# UNITED STATES PATENT AND TRADEMARK OFFICE

APPLICATION NO.	FILING DATE	FIRST NAMED INVENTOR	ATTORNEY DOCKET NO.	CONFIRMATION NO.
09/852,994	05/10/2001	Berthold N. Schmidt	721-1000	5821

**Office Action Summary**

**DETAILED ACTION**

**FIG.2C**

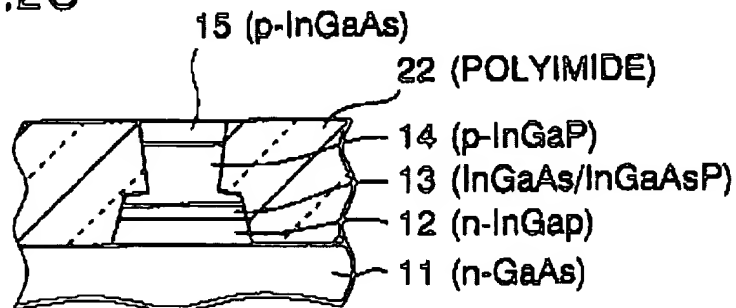
6. Claims 1, 3-5, 8 are rejected under 35 U.S.C. 102(b) as being anticipated by Arakawa et al (5,757,833). Arakawa et al discloses the claimed invention. Regarding claim 1 and its dependent claims, note figures 2c, 3c, 8 for the following features:

1. A semiconductor ridge waveguide laser diode including a semiconductor body (11) an active region (12, 13, 14) including a ridge (see col. 9 line 52, and col. 10 lines 27-30), front and back facets each with a mirror (23,24), a metallization (17) over said body and said ridge for injecting carriers into said active region (12,13,14) characterized by means (21) for limiting said injection of carriers by providing an unpumped section in the vicinity of said front and/or said back facet.

3. The laser diode according to claim 1, wherein the means for limiting the injection of carriers is an isolation layer (21) between the laser diode's active region (12, 13, 14) and the metallization (17).

4. The laser diode according to claim 3, wherein the isolation layer (21) between the laser diode's active region (12, 13, 14) and the metallization (17) is made from  $\text{SiO}_2$ ,  $\text{Al}_2\text{O}_3$ ,  $\text{TiN}$  or, preferably,  $\text{SiN}$ .

5. The laser diode according to claim 3, wherein the isolation layer (21) is extending under only a fraction of the area of the metallization (17).

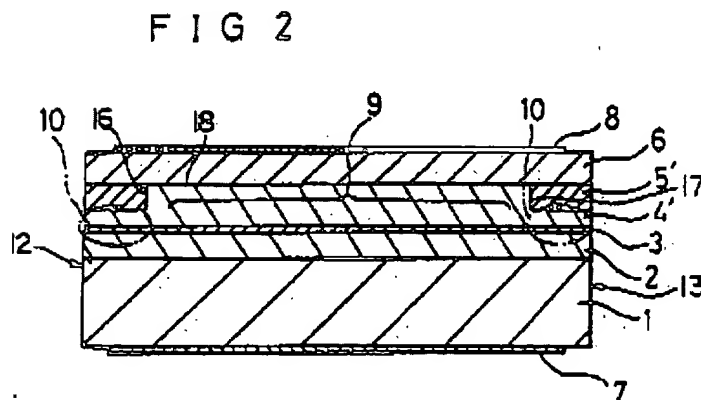
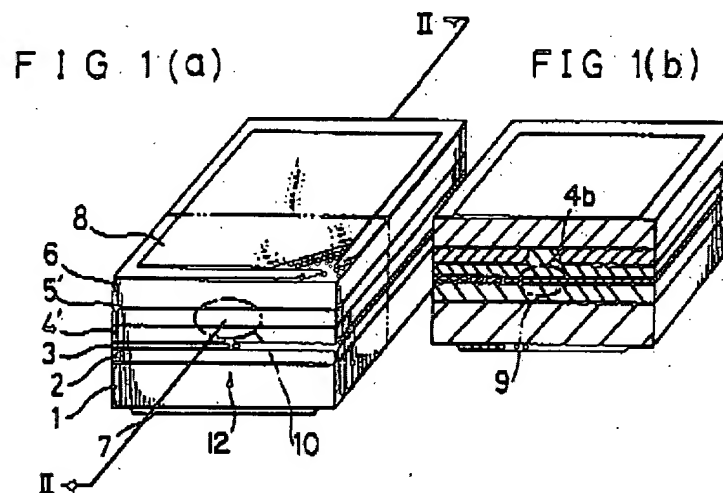
7. Claims 1-3, 5 are rejected under 35 U.S.C. 102(b) as being clearly anticipated by Mitsui et al (4,964,135). Mitsui et al clearly discloses the claimed invention.

least one of its ends as illustrated in FIG. 2. The current blocking layer 5' forms a rectifying junction with the layer 4', reducing the current injection and carrier re- 45 combination at the facets 12 and 13 compared to other laser structures.

**FIG. 1**

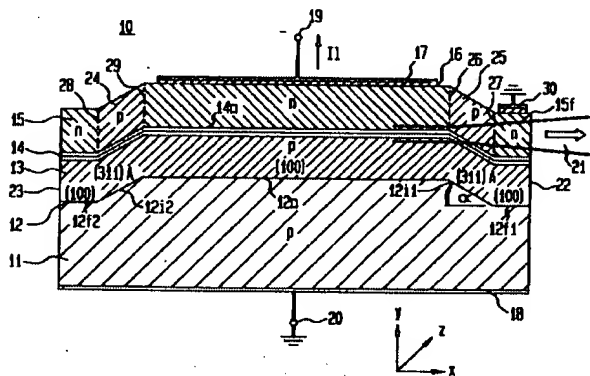
8. Claims 1-2 are rejected under 35 U.S.C. 102(b) as being clearly anticipated by Gfeller et al (5,280,535). Gfeller et al clearly discloses the claimed invention.

Still another object is to provide a laser diode of a 5  
rather simple structure that can be fabricated using  
conventional easy-to-control processes and that fulfills  
the dual purpose of terminating the active waveguide  
with a wide-bandgap zone and of preventing injected  
lateral currents from flowing into the mirror facet zone. 10
